## HISTORIC PRESERVATION COMMISSION

SUBJECT: Permit # 11088225 - Hardscape alteration and trash enclosure

Applicant: Rebecca & Rob Nichols  
Address: 5918 Cedar Pwky, Chevy Chase

## Tree Preservation Plan – 5918 Cedar Parkway

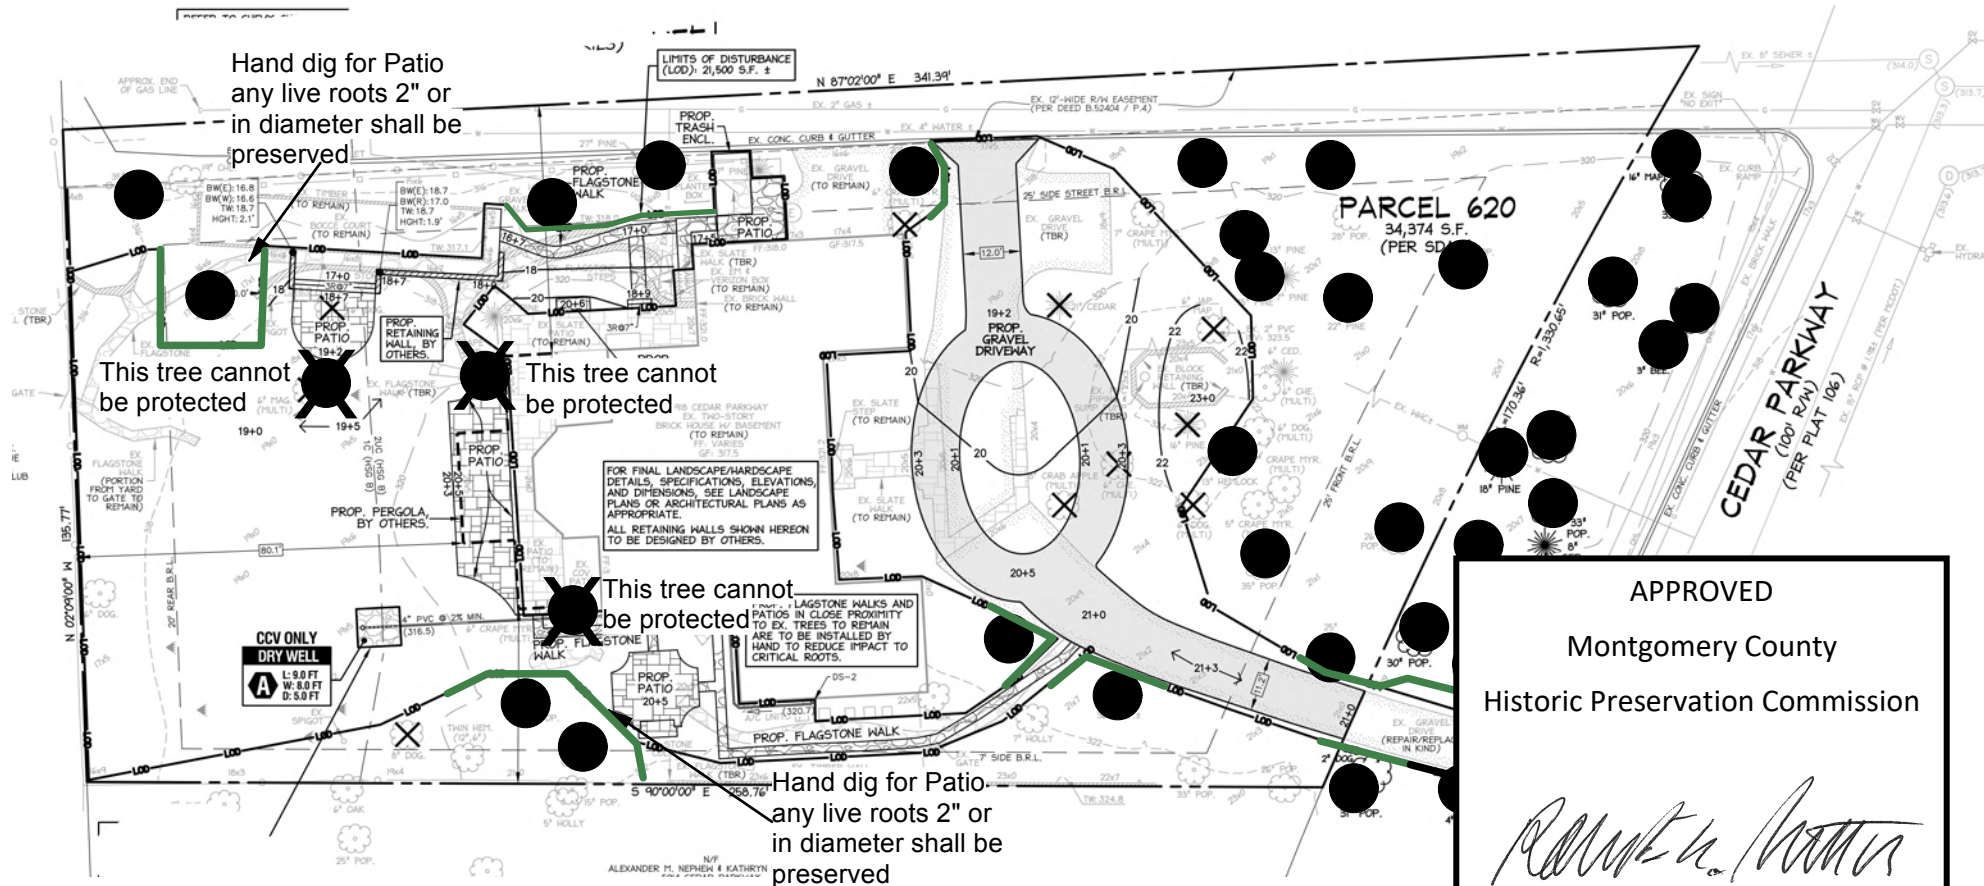
I recommend the issuance of the Building Permit conditioned on the Owner's compliance with the tree preservation plan shown on the attached sheet and as stated below.

1. Tree preservation fencing shall be installed in the locations shown on the plan. The street tree shall be protected. Tree preservation fencing shall delineate the tree protection zones. Tree preservation fencing shall be 4' tall wire mesh supported with steel stakes no less than 8' apart.

2. The Owner/Contractor shall inform all on-site workers that the tree preservation zones shall not be entered. Neither materials nor equipment shall be stored within the tree preservation zones. No grading shall be done within the tree preservation zones. The grading outside the tree preservation zones shall not be changed to divert and collect water within tree preservation zones.

3. No super silt fencing shall be installed within 10' of protected trees.
4. No storage of materials or equipment within 15' of protected trees..
5. Where indicated, excavations shall be done by hand. Any live roots 2" or more in diameter shall be preserved.

6. If excavation exposes roots on protected trees, the damaged roots shall be cleanly cut.
7. The Chevy Chase Village office shall be notified of any construction plan changes.

Note: As shown, two crepe myrtle trees cannot be protected if the new patios are installed.
